FACPAC Contract Change Order

Tier 1 Project: Phase 6 Additions and Renovations - Project #175-520

CHANGE ORDER NUMBER: 203-01
INITIATION DATE: 1/26/2023

PR # 12 Add Glass Openings into Classroom 204

G26

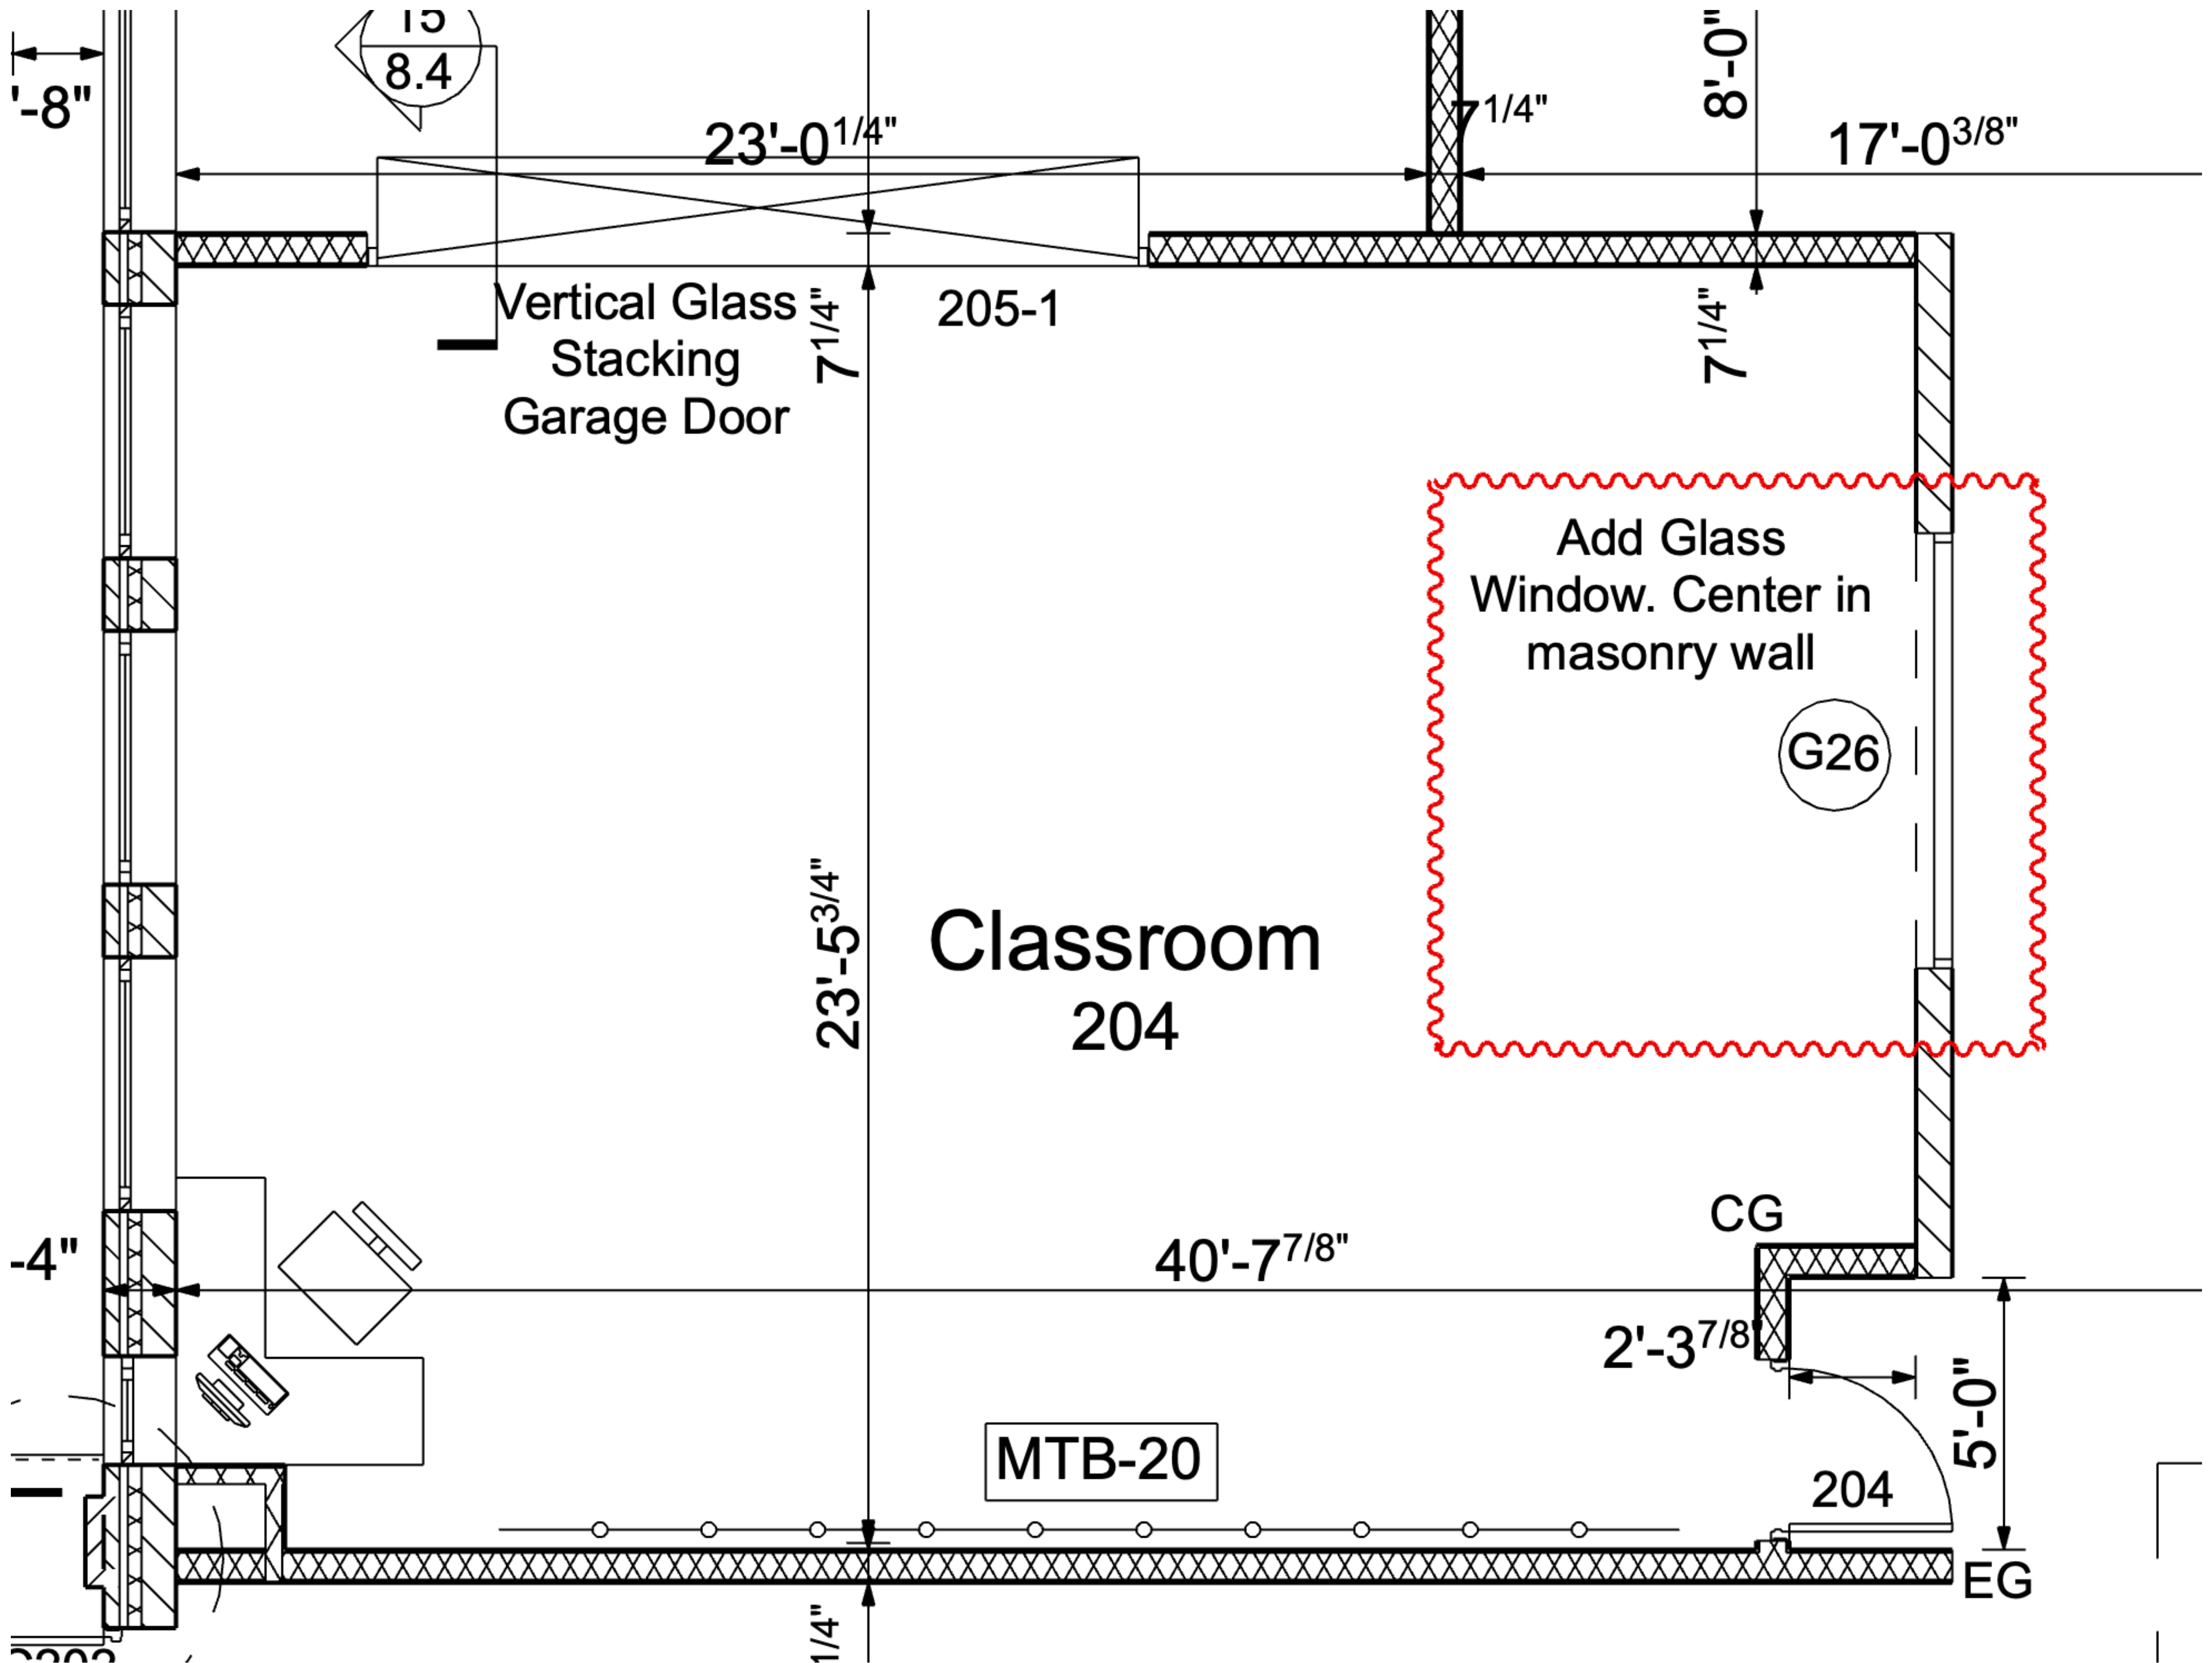
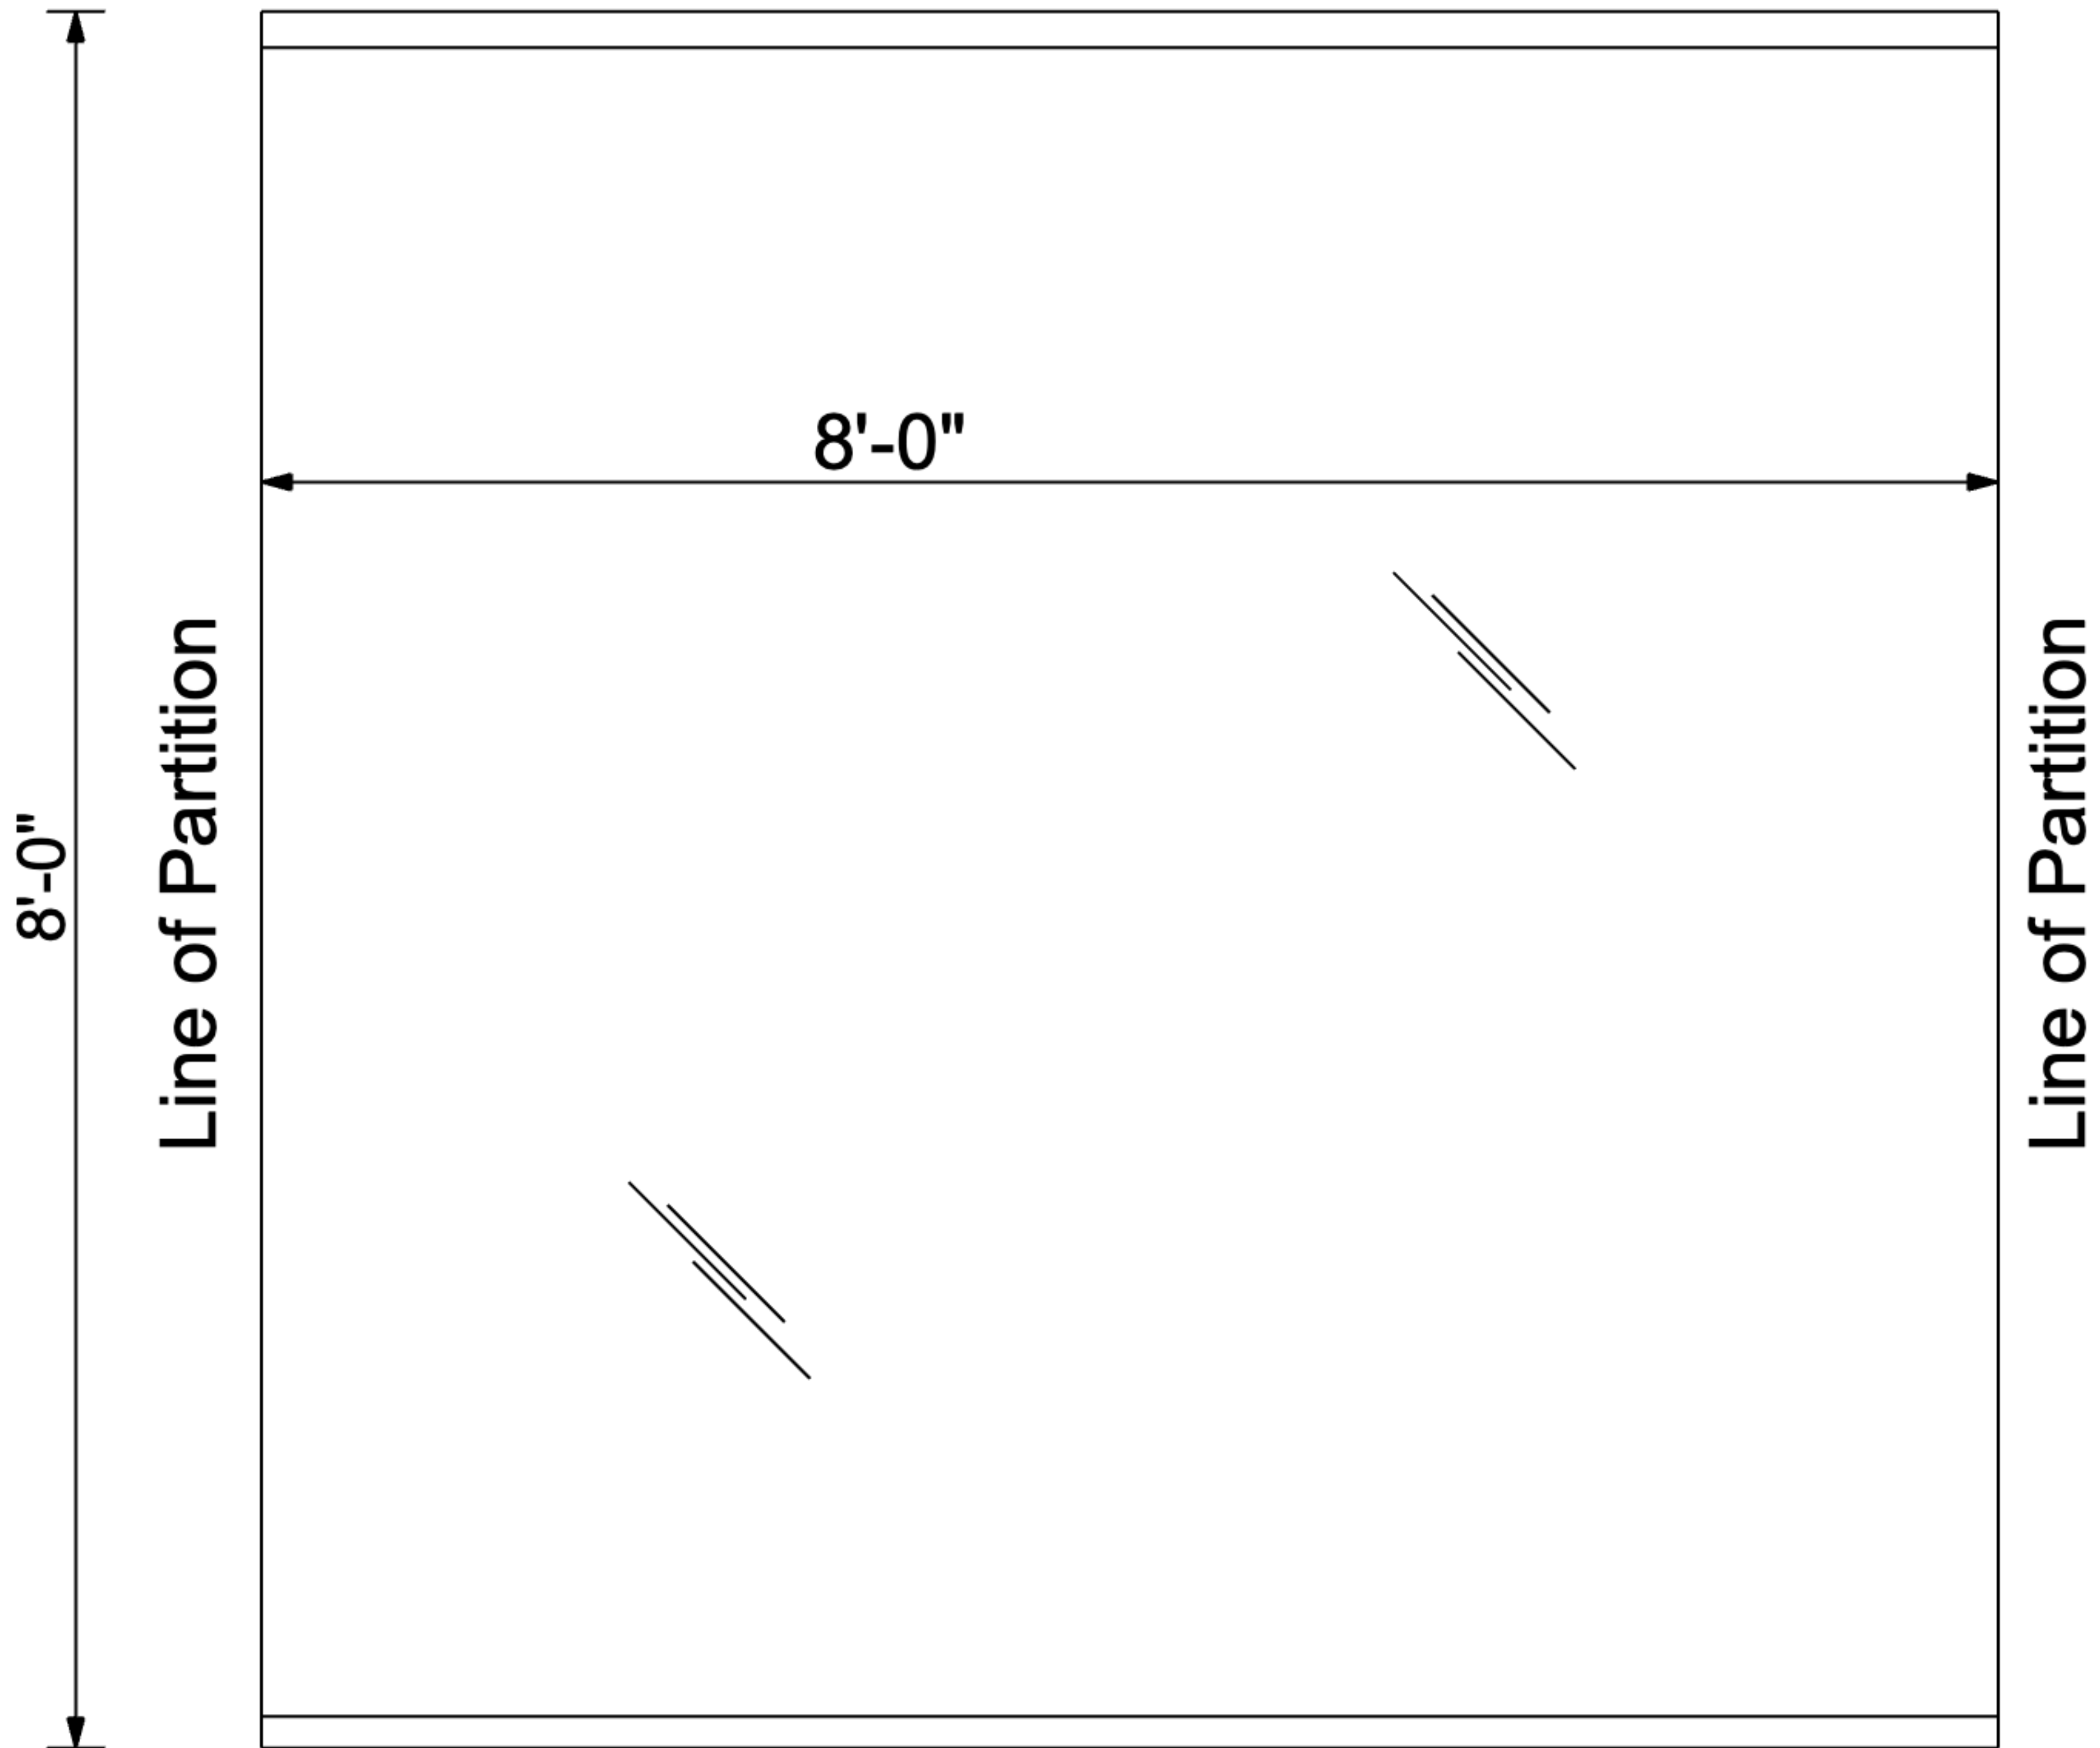
The owner would like a price to add the attached glass openings into Classroom 204.
Provide the following lintel over the opening.

8x8 BOND BEAM w/ (2) #5 CONT. AND W8x18 w/ 1/2"Ø x 5" LONG HEADED STUDS @ 16" c/c
8" BEARING EACH END
